PROPOSED SITE PLAN

PETITION NO: Z-34

The applicant is requesting the LRO zoning district to develop a one-story office building. The proposed building would have a brick, stone and/or stucco exterior. The proposed office would be open Monday through Friday, from 8:00 a.m. to 6:00 p.m. The applicant has submitted a Zoning Impact Analysis, which is attached as Exhibit "A".

Z-34 CALBERT ENTERPRISES, LLC

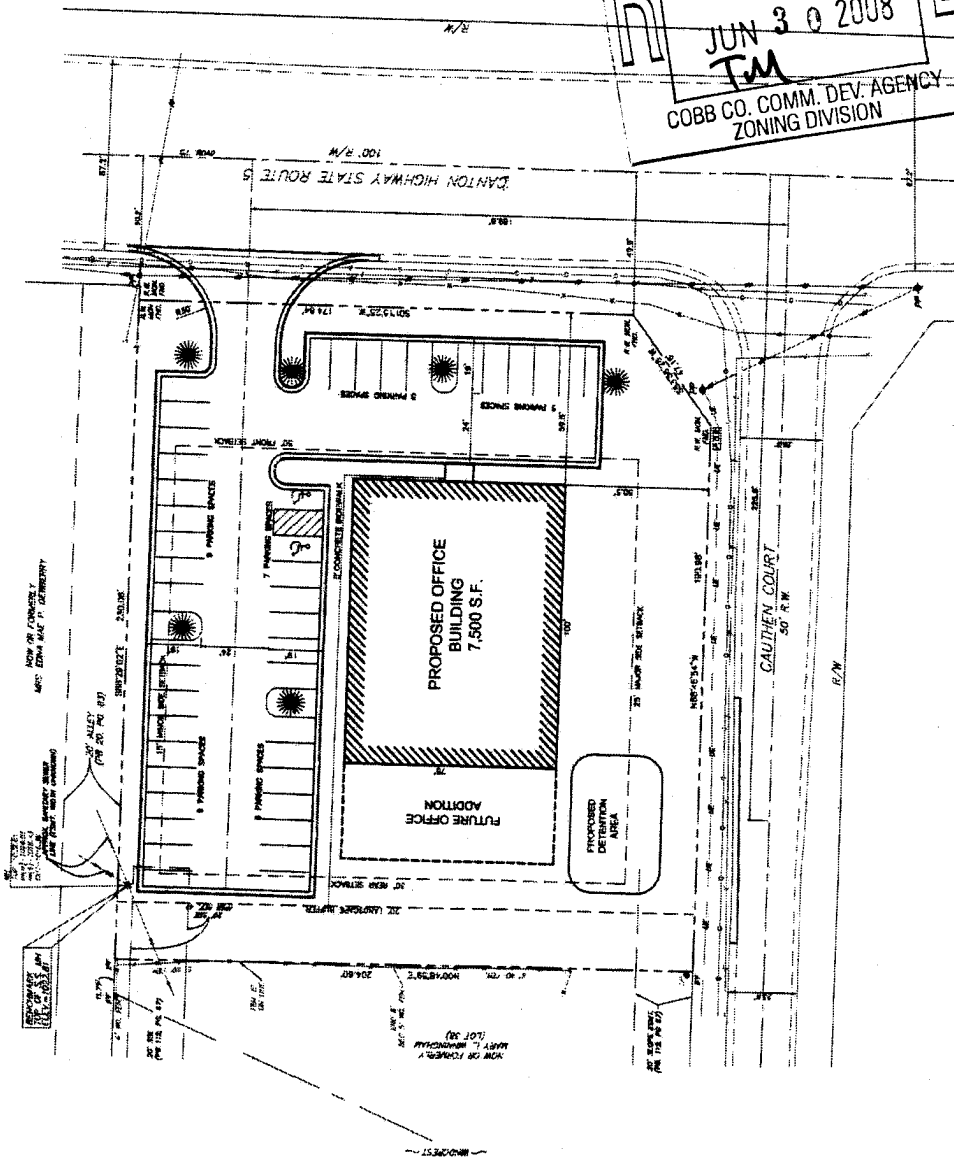
- ☐ Provide comprehensive hydrology/stormwater controls to include development of out parcels.
- ☒ Submit all proposed site improvements to Plan Review.
- ☐ Any **spring activity** uncovered must be addressed by a qualified geotechnical engineer (PE).
- ☐ Structural fill _____ must be placed under the direction of a qualified registered Georgia geotechnical engineer (PE).
- ☐ Existing facility.
- ☒ Project must comply with the Water Quality requirements of the CWA-NPDES-NPS Permit and County Water Quality Ordinance.
- ☐ Water Quality/Quantity contributions of the existing lake/pond on site must be continued as baseline conditions into proposed project.
- ☒ Calculate and provide % impervious of project site.
- ☒ Revisit design; reduce pavement area to reduce runoff and pollution.

1. The detention pond discharge must be tied directly into the existing downstream system. The allowable design discharges will be subject to the existing available system capacity.
2. Adequate landscape screening must be provided between the proposed detention facility and the adjacent residential lot. The pond must be relocated outside the required landscape buffer. Any exposed concrete pond walls must be decoratively faced.

No access to Cauthen Court.

Install sidewalk, curb and gutter along both road frontages.

Recommend no access to Cauthen Court.

Recommend installing sidewalk, curb and gutter along both road frontages.

- Site plan received by the Zoning Division June 30, 2008, with the District Commissioner approving minor modifications;
- Final building architecture meet the architectural guildlines from the 2005 Canton Road Corridor Study;
- Fire Department comments;
- Water and Sewer comments and recommendations;
- Stormwater Management comments and recommendations;
- DOT comments and recommendations;
- owner/developer to enter into a Development Agreement pursuant to O.C.G.A. §36-71-13 for dedication of system improvements to mitigate traffic concerns.
